[Docket No. FAA-2020-0442; Project Identifier AD-2020-00260-E; Amendment 39-21640; AD 2021-14-13]

Airworthiness Directives; Pratt & Whitney Turbofan Engines

ACTION: Final rule.

Figure 1 to Paragraph (g)(1)(iii) – Crack Inspection Critical Areas

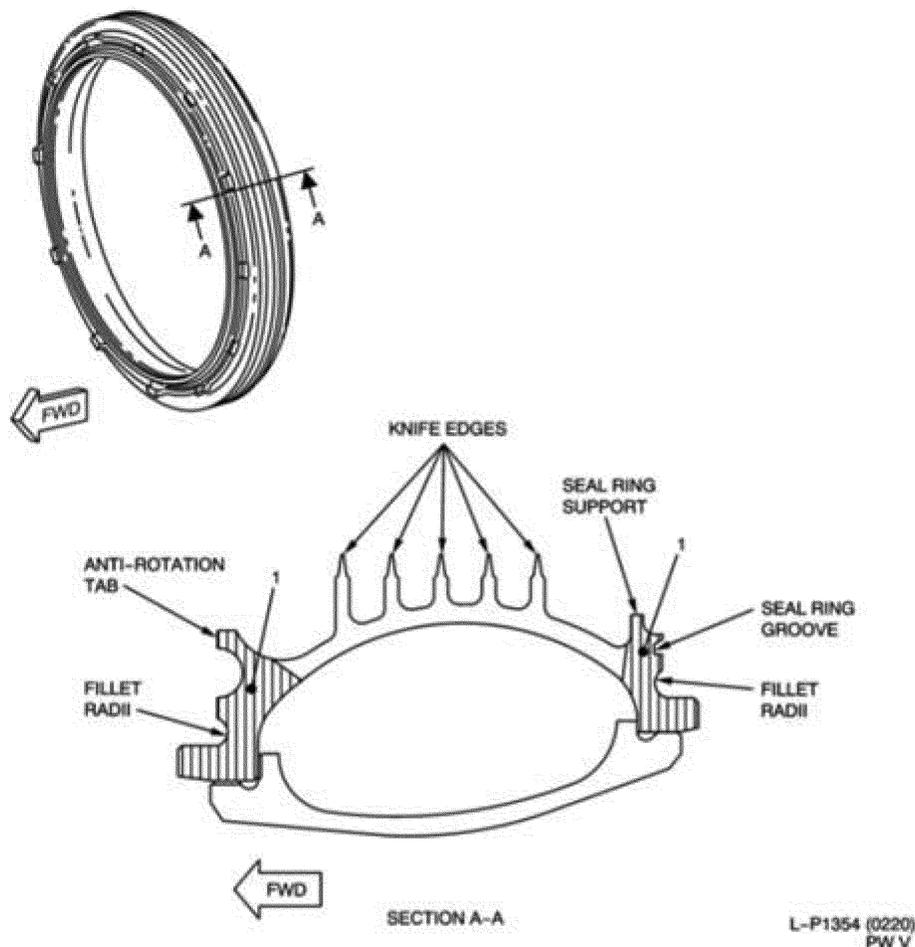
Delta and MTU requested that the FAA clarify the location of the forward and aft edges of the HPT 2nd-stage air seal assembly. Delta asked if the forward edge is the barrel section forward of the #1 knife-edge or any part that extends beyond the barrel section.

Delta and FedEx requested that the FAA clarify the definition of "through-crack." Delta asked if a "through-crack" is a crack going through the axial direction or radial direction of the HPT 2nd-stage air seal assembly. Delta referenced Figure 5 of NDIP-1217 that appears to show a through-crack in the axial direction. Delta inferred from paragraph (i)(4) of the NPRM that a through-crack is in the radial direction. Delta requested a diagram to help illustrate what constitutes a through-crack.

FedEx stated that a lenticular seal is a two-piece component that becomes an inseparable assembly during manufacturing. As a result, it would be impossible to distinguish a through-crack from a surface crack over a large area of the HPT 2nd-stage air seal assembly's exterior since its interior surfaces are inaccessible. FedEx cited Chapter 72-52-60, Inspection/Check-01, Figures 801 and 801A, of the PW2000 Series Engine Manual, which highlights areas where through-thickness cracks are critical. According to FedEx, however, these images fail to address the ability to determine whether a surface crack is a "through-crack." Additionally, the PW2000 Series Engine

If a crack is found as identified in the shaded region of Figure 1 to paragraph (g)(1)(iii) of this AD (Figure 1) that

extends toward the knife-edge region of the HPT 2nd-stage air seal assembly, this AD requires replacement of the HPT 2nd-stage air seal assembly, mating HPT 1st-stage disk, and HPT 2nd-stage hub.

The FAA removed references to "forward edge" and "aft edge" of the HPT 2nd-stage air seal assembly from this AD. In their place, the FAA added Figure 1 to paragraph (g)(1)(iii) of this AD to specify the locations of the HPT 2nd-stage air seal assembly that require inspection for cracks.

The FAA agrees that it is difficult to differentiate between a surface crack and through-crack; therefore, the FAA removed references to “through-crack” from this AD. The FAA notes that any crack, in any direction, found in the HPT 2nd-stage air seal assembly, requires removal of the HPT 2nd-stage air seal assembly from service. As stated in an earlier response, the FAA added Figure 1 to show the locations of the HPT 2nd-stage air seal assembly that require inspection for cracks. However, the FAA is not providing dimensions that bind the areas. If the inspections of the HPT 2nd-stage air seal assembly reveal a crack in the shaded regions of Figure 1, which extends towards the knife-edge region, the HPT 2nd-stage air seal assembly must be removed from service.

(iii) During the visual inspection or FPI required by paragraph (g)(1)(i) of this AD, if a crack is found in the shaded regions of the HPT 2nd-stage air seal assembly identified in Figure 1 to paragraph (g)(1)(iii) of this AD (Figure 1), which extends towards the knife-
